To: All Interested Bidders and Plan Holders
From: Jennifer Steed, Senior Project Manager
RE: Lake Myra County Park Phase 1 (RFB#26-077)
Addendum No. 4 – FINAL ADDENDUM
Date: September 30, 2026

TYPICAL BRIDGE
DETAILS

LAKE MYRA COUNTY PARK
Wake County, NC

BOARDWALK PLANS

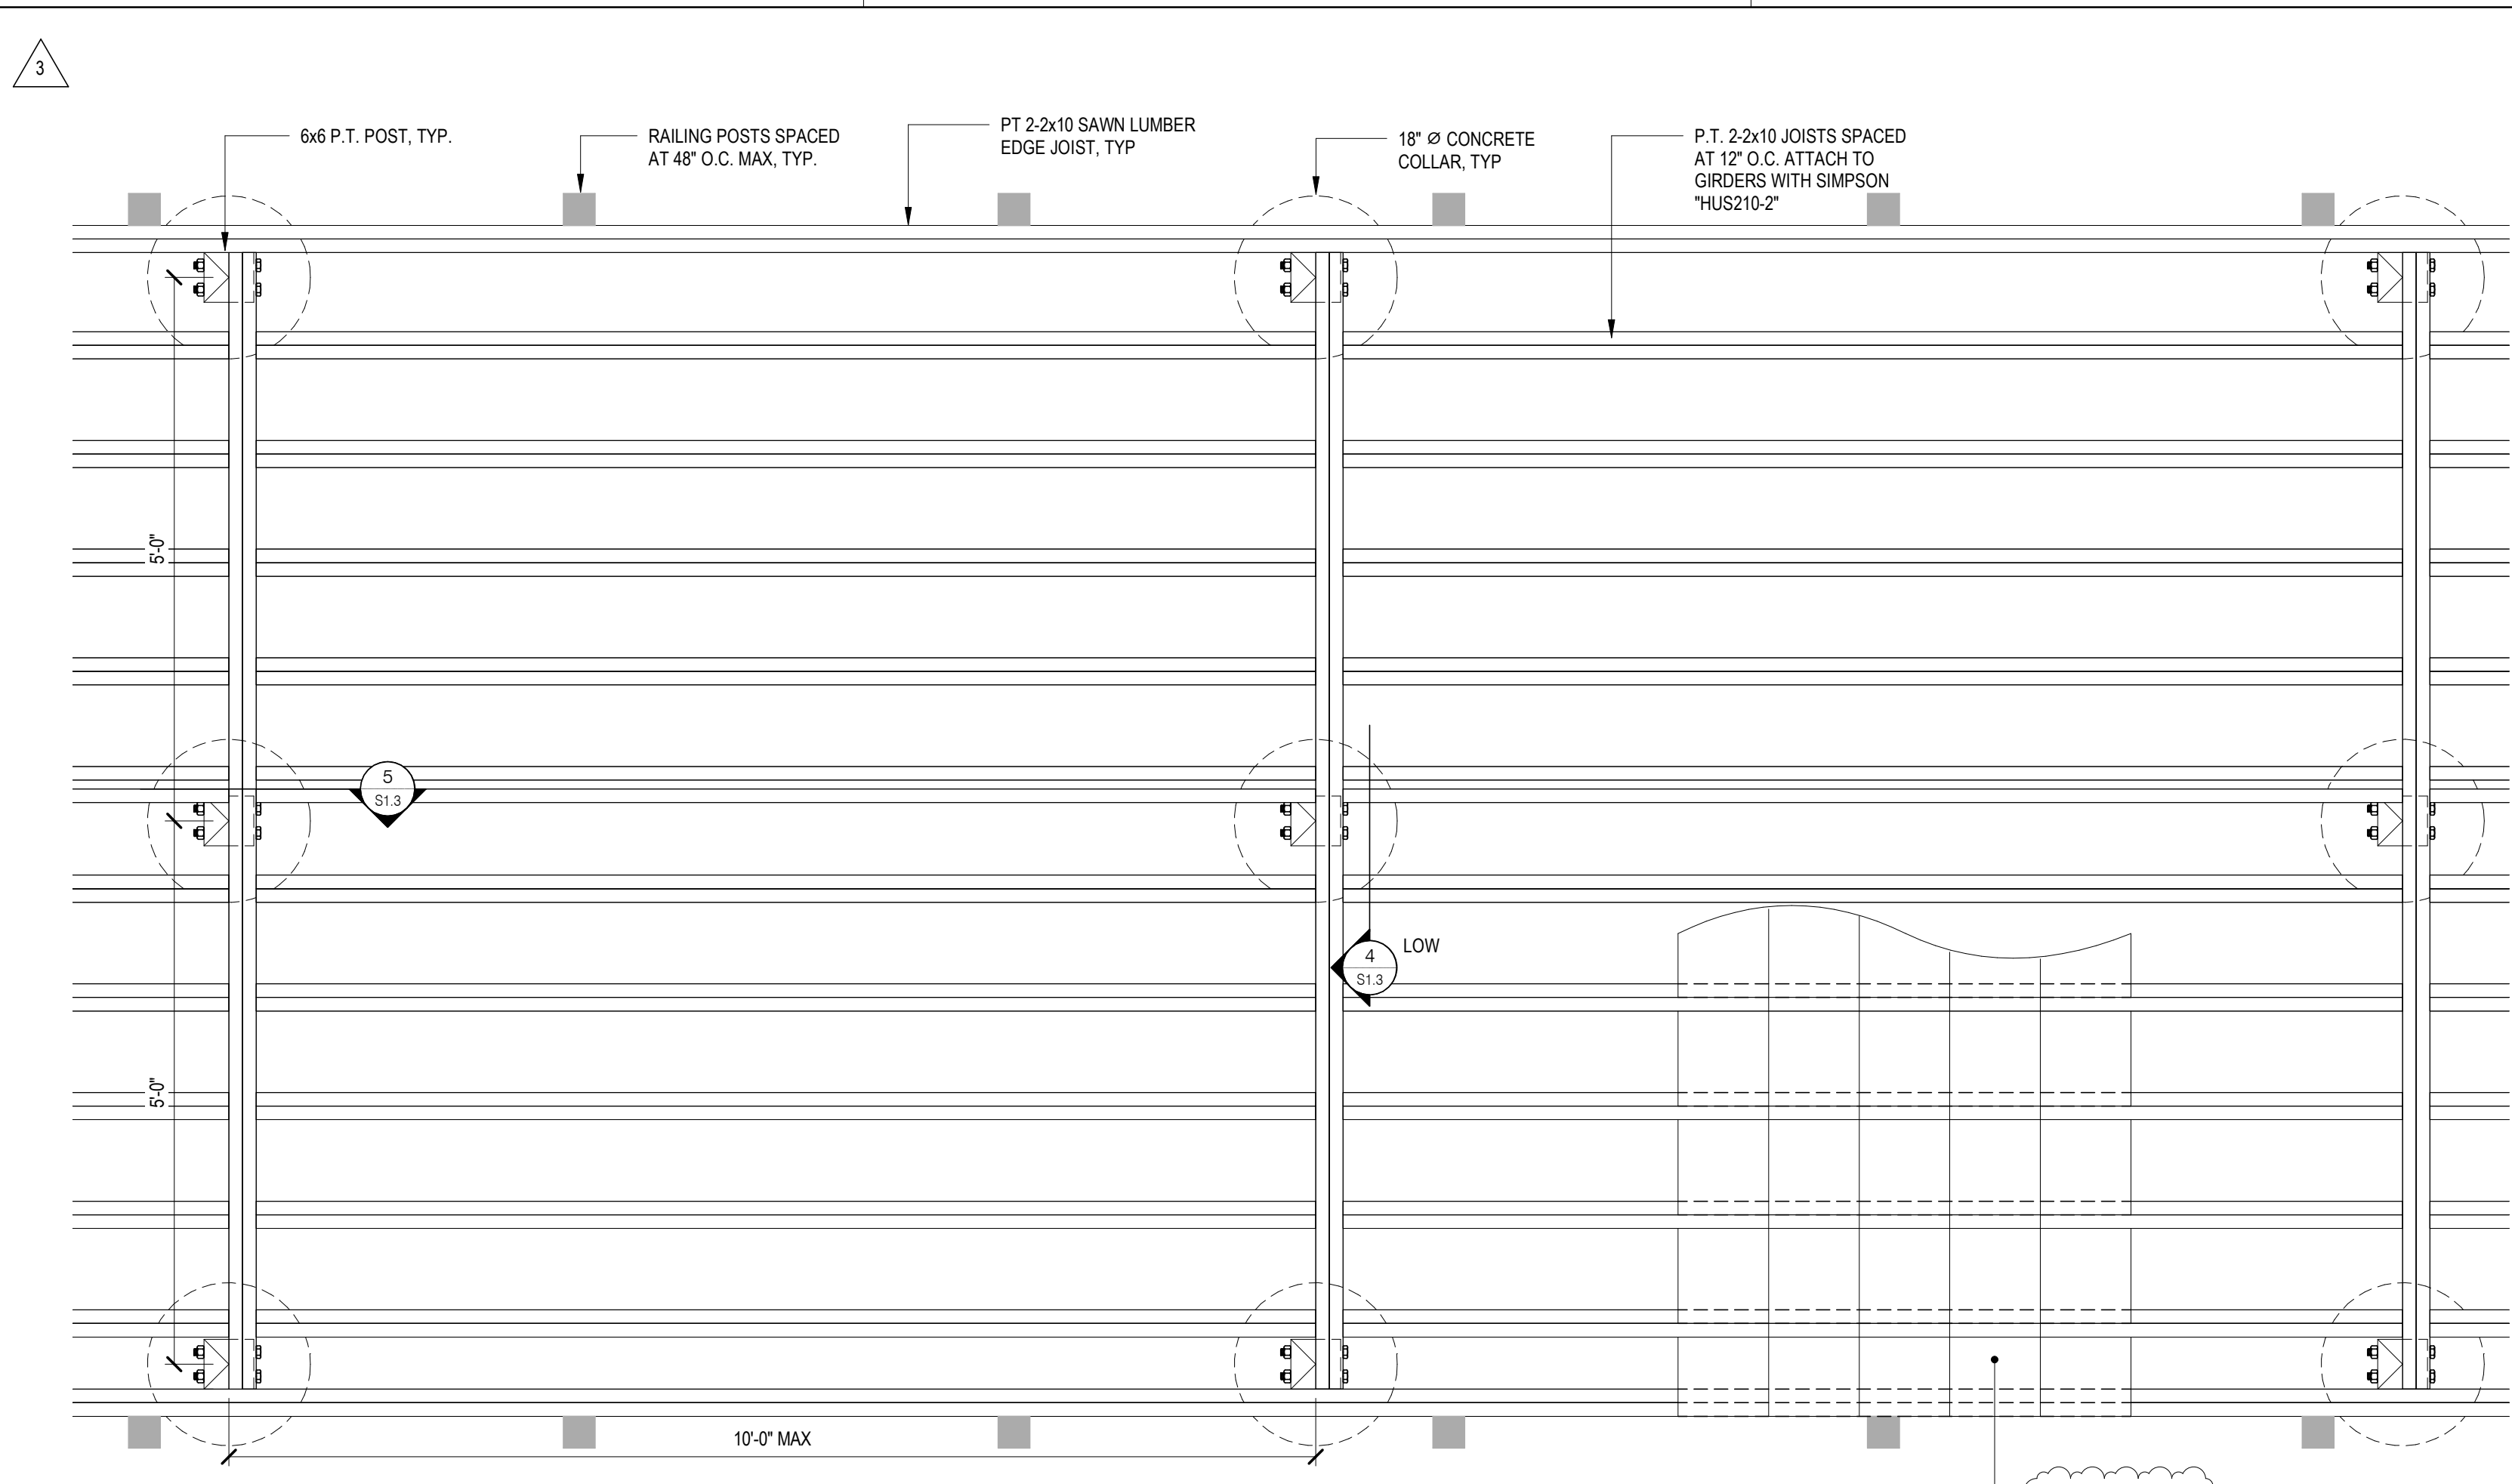
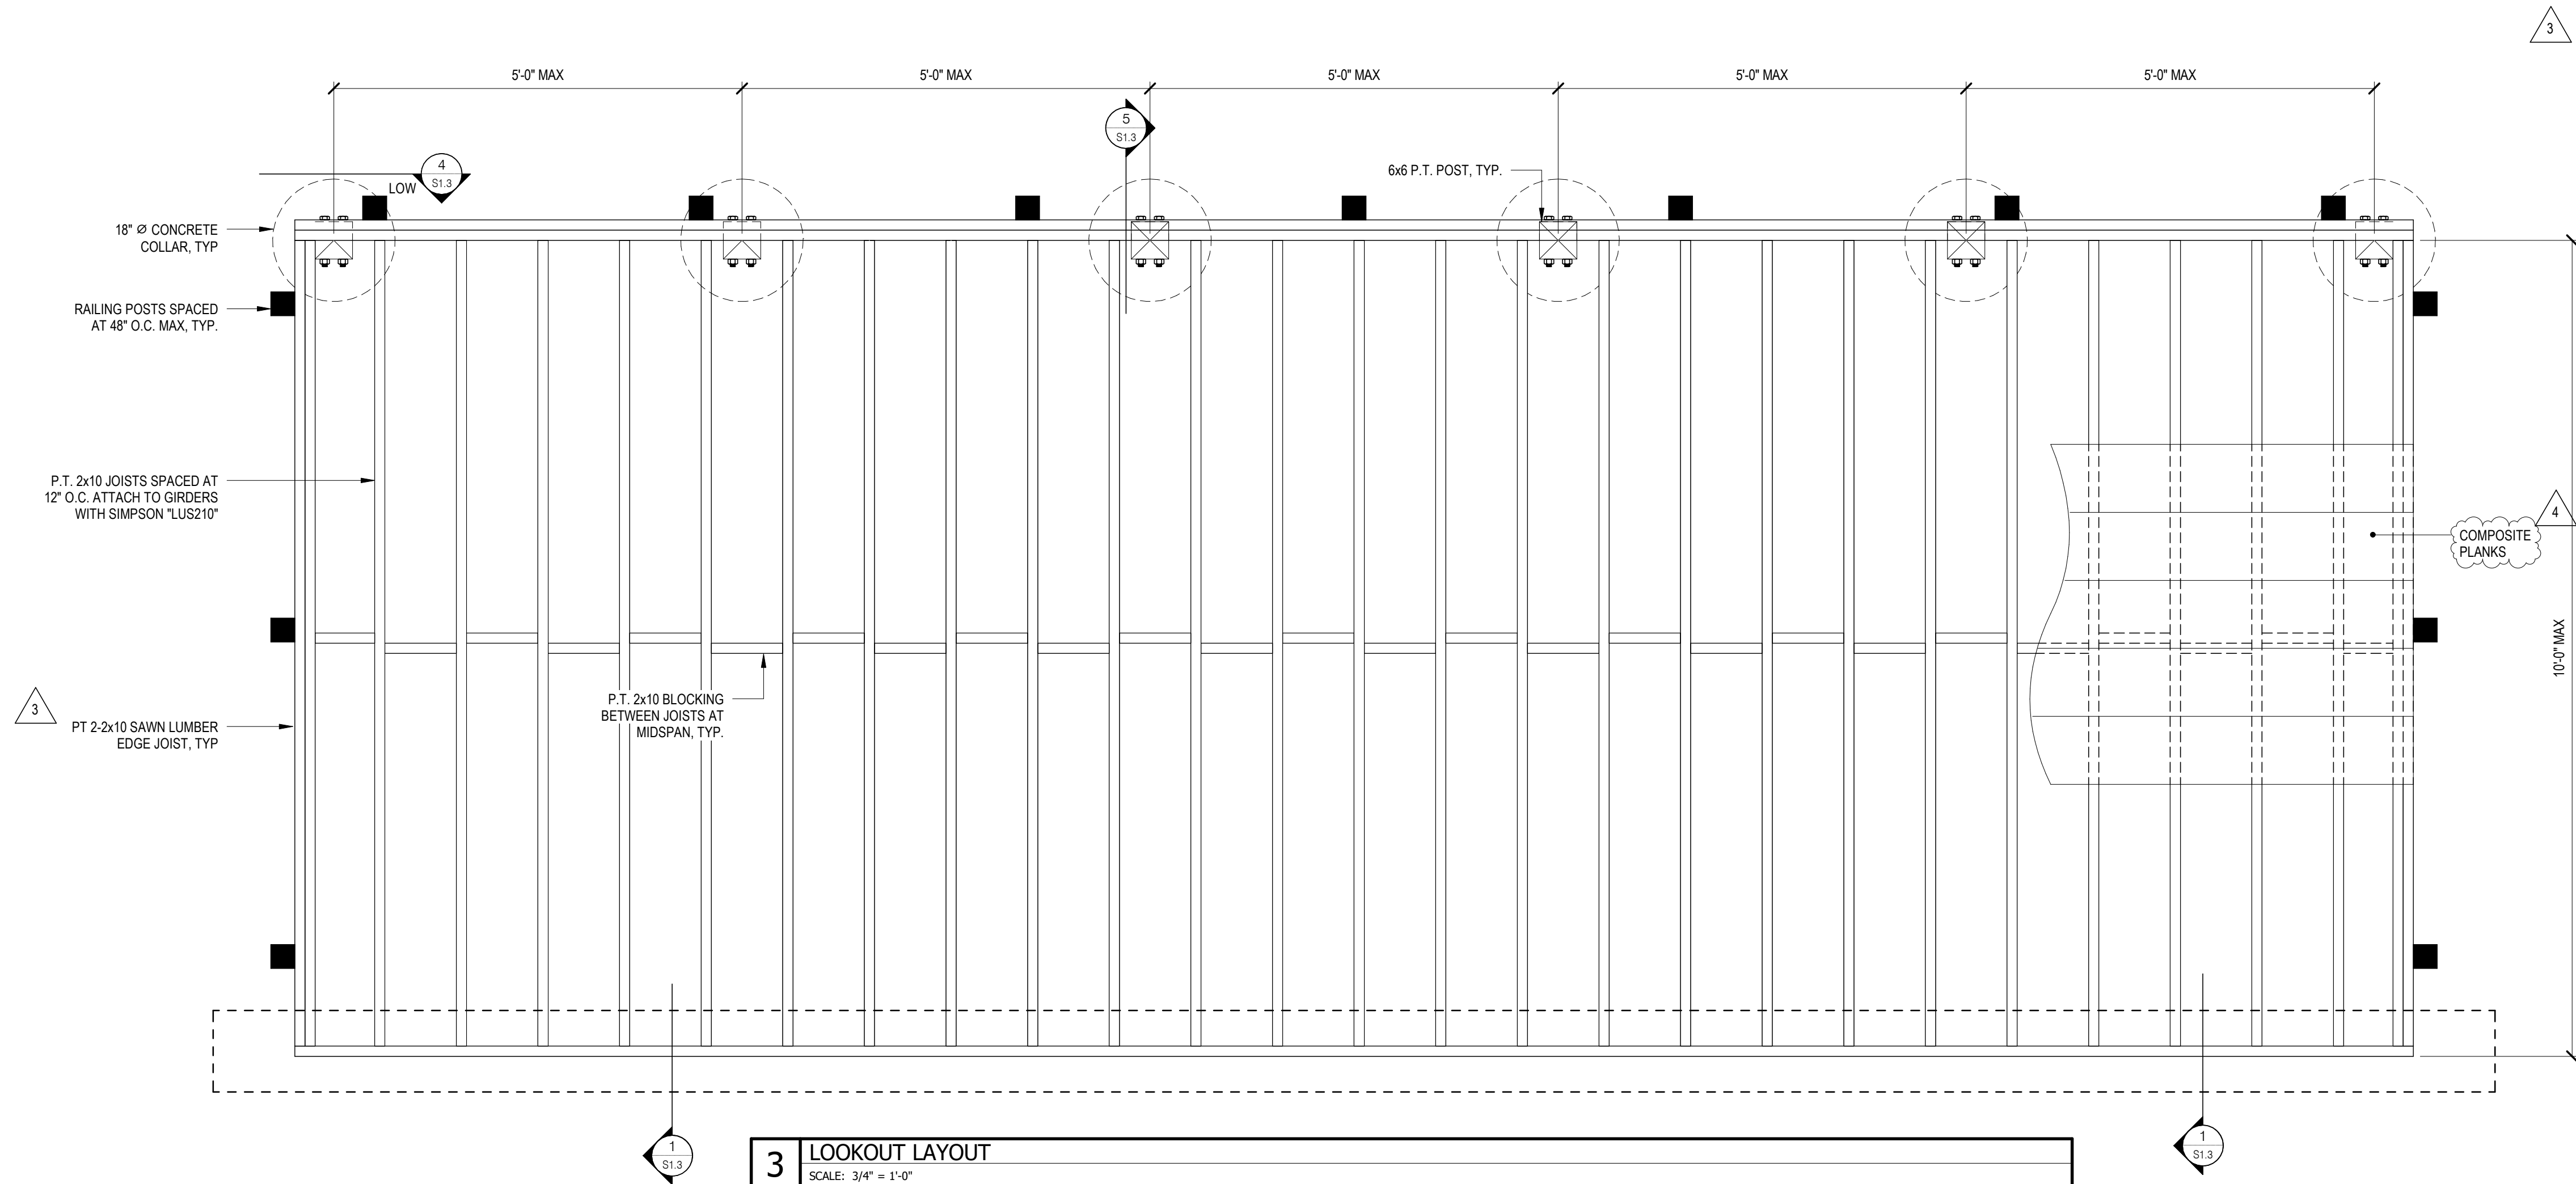
3	ADDendum 3	10/26/2026
4	ADDendum 4	10/26/2026
